Subject: Lake Powell Hydroelectric Project No. P-12966-001: Initial Study Report

Please accept this corrected comment letter and substitute it for the original submitted by EDF on May 6, 2011.

Figure 1. Colorado River Basin Historical Supply and Use (figure prepared by Reclamation and published in Reclamation et al., 2009).

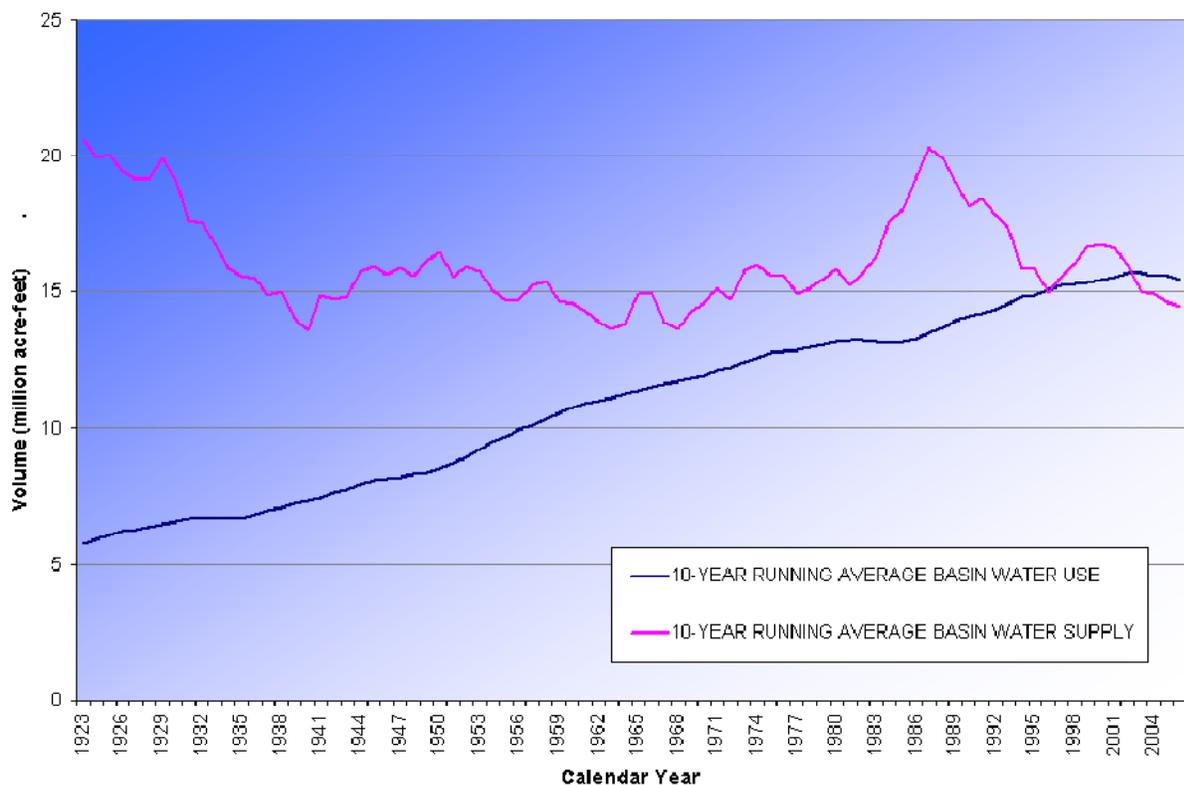
Significantly, the Colorado River has entered the age of limits. Figure 1, prepared by Reclamation, depicts 10-year average supply and demand totals for the Colorado River basin, and illustrates that since 2002 demands have exceeded supply. This is nowhere more evident than in the declining volume of water in storage throughout the basin. The Commission and the project proponents must acknowledge that while new demands for Colorado River water may be supplied out of storage in the short term, the inevitable, long-term result is that a new demand in a system already fully used will either itself be shorted, or will result in a shortage to another water use somewhere else in the system.

Figure 2. Average annual total system hydrologic inflows for the Colorado River Basin through 2060.¹

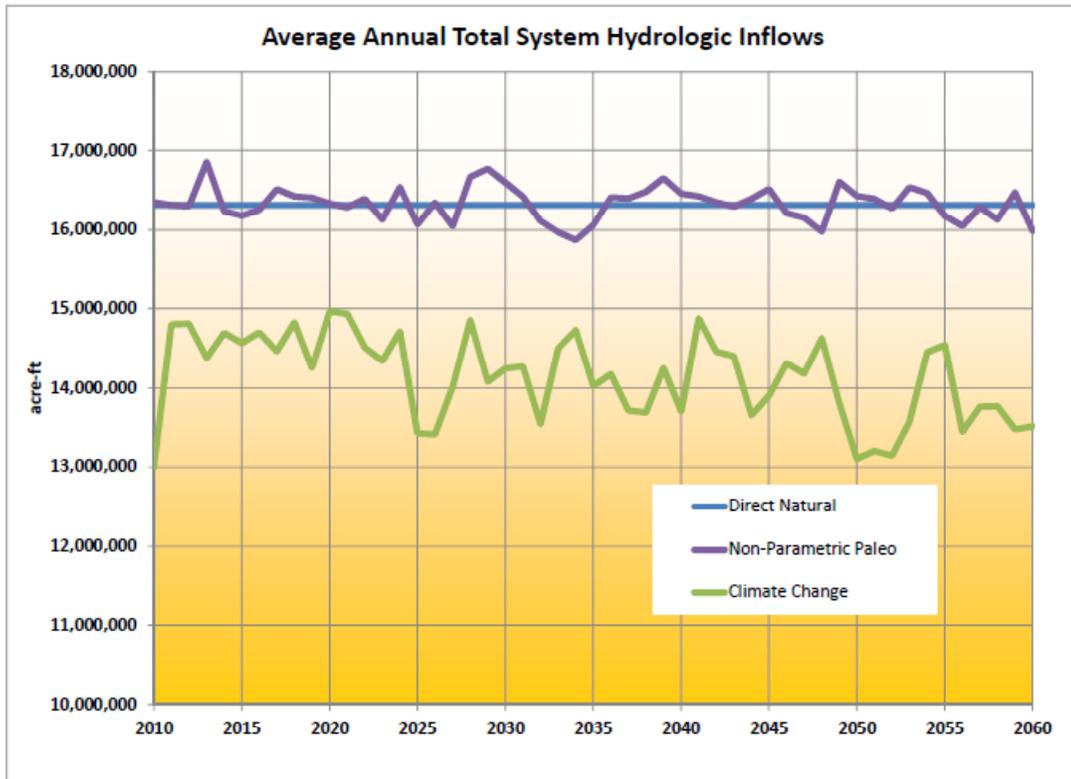
Figure 2, below, compares total basin inflows under three hydrologic inflow scenarios developed by Reclamation (direct natural, non-parametric paleo-conditioned, and climate change) and demonstrates that the climate change flow scenario is considerably drier than either the direct natural or non-parametric paleo-conditioned flow scenarios.

Figure 3. Projections under climate change scenario of the probability of Lake Powell falling below 3375 feet through 2060.ⁱⁱ

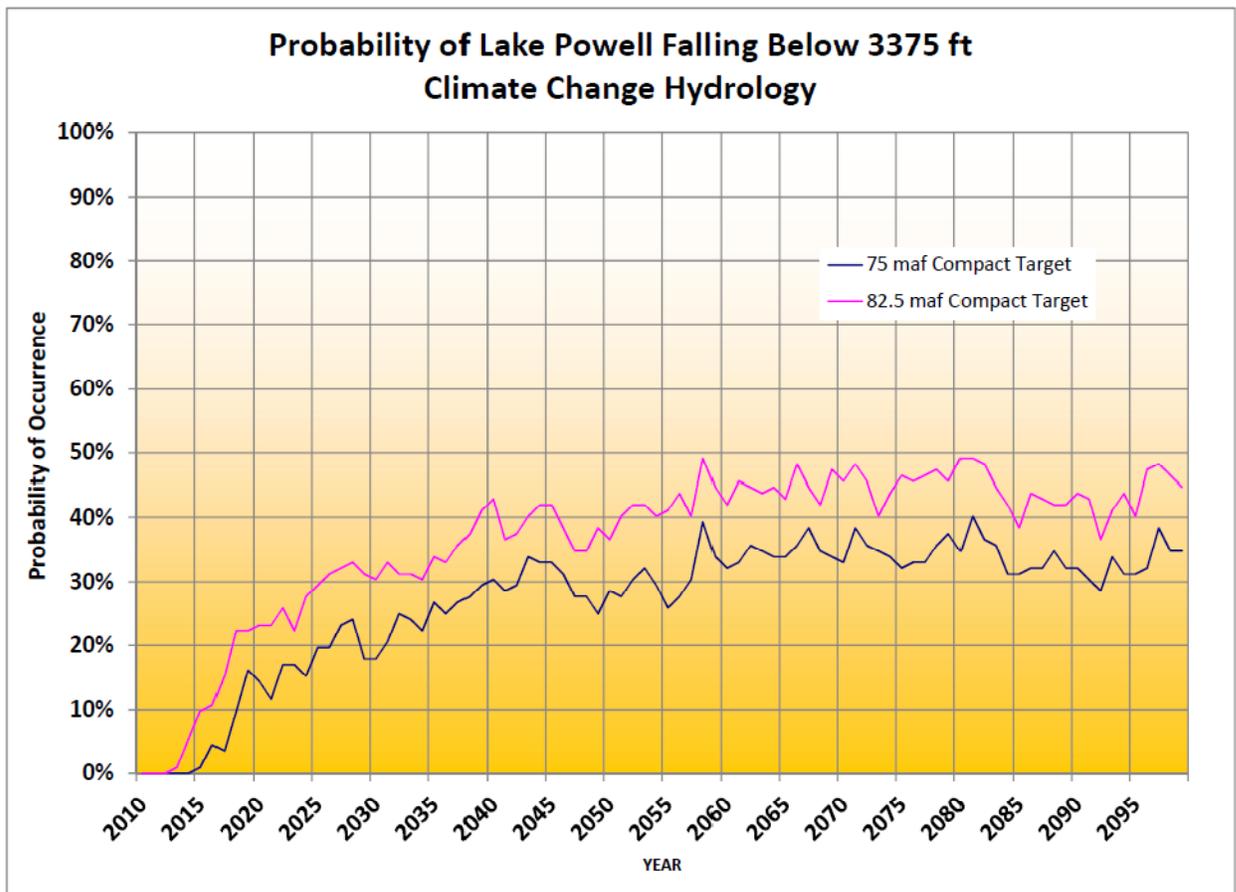
We prepared an independent CRSS analysis of Lake Powell water supply that uses a climate change inflow scenario similar to that published in Reclamation’s SECURE report, and assumes Compact deliveries at the 75 million acre-foot level. This analysis projects a 27% probability that the water surface elevation in Lake Powell would be below 3375 feet msl (the stated intake level for the proposed project) in any given year between 2010 and 2099 (see figures 3 and 4). If the compact delivery obligation is assumed to be 82.5 million acre-feet the probability of Lake Powell falling below 3375 feet msl increases to as much as 37%. We urge the Commission to require the project proponent, working with Reclamation, to replicate these analyses themselves. We urge the Commission to find that study report 19 has not been properly conducted because the analysis does not consider hydrologic conditions projected for the time period during which the project is proposed to be operational, and because the CRSS analysis used is flawed in that it does not demonstrate implementation of the Compact.
